CPED STAFF REPORT

Prepared for the Heritage Preservation Commission

HPC Agenda Item #1
September 9, 2014
BZH-28333

Property Location: 2412 1st Avenue South
Project Name: Porch Replacement
Prepared By: [Lisa Steiner](#), City Planner, (612) 673-3950
Applicant: Omega One, Ltd.
Project Contact: Josh DuBois
Ward: 10
Neighborhood: Whittier
Request: To allow the replacement of a non-historic rear porch and maintain the existing side yard setback.

View of the existing porch from the rear of the house.

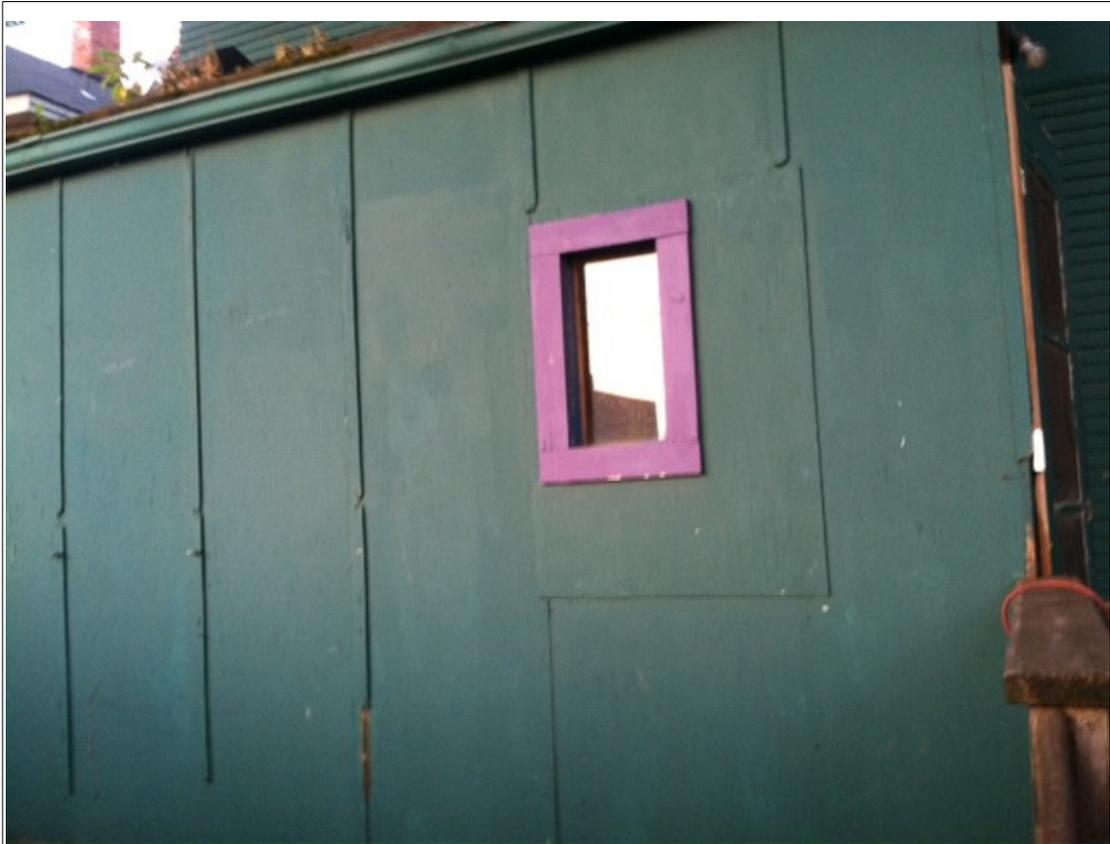
The existing porch has a shed roof which does not match the house, and missing or unfinished trim. (Also, note the band of plywood siding at the top of the porch, which we intend to replace with clapboard matching the rest of the house's siding.)

The existing porch has a single, undersized window without details that match other windows. The siding of the existing porch is plywood and does not match the wooden clapboard on the rest of the house.

The bottom of the existing porch suffers from rot and decay. There is no foundation.

The existing porch is supported only by wooden posts.
